A development application has been received for demolition of existing structures and construction of a shopping centre including a supermarket (shop), medical centre and speciality shops, parking and landscaping on the site. The application has been examined having regard to the matters for consideration detailed in section 79C of the Environmental Planning and Assessment Act and other statutory requirements with the issues requiring attention and consideration being addressed in the report.

JRPP No:	2011HCC023
Applicant	Fabcot Pty Ltd C/- The Planning Group
Owner	Fabcot Pty Ltd
Application No	DA/459/2011
Description of Land	275 Pacific Highway, Lake Munmorah, Lot 2 DP.520220
Proposed Development	Demolition of existing structures and construction of a shopping centre including a supermarket (shop), medical centre and speciality shops, parking and landscaping.
Site Area	8.167 hectares
Zoning	3(a) Business Centre and 7(a) Conservation
Existing Use	Vacated rural landscape supplies centre
Employment Generation	250 (full time, part time, apprentices & casual staff)
Estimated Value	\$14,751,000

Western elevation before amendment

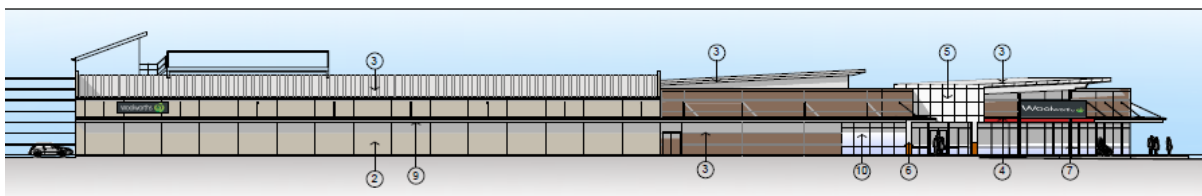
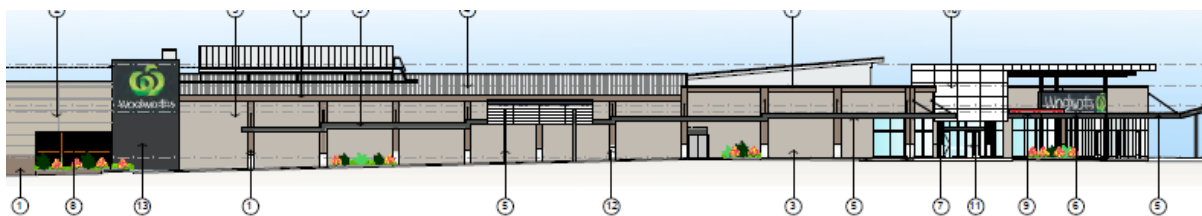
However, concerns were initially raised regarding the external design and appearance of the development and further visual treatment was requested. The DCP requires *building designs include surface relief or surface patterns which achieve a balance in horizontal and vertical articulation of the facades so as to avoid large buildings with unmodulated blank walls and no variation in architectural treatment*. The applicant submitted an amended finishes schedule and elevation plans that provides greater architectural expression and visual interest to the building.

Western elevation after amendment
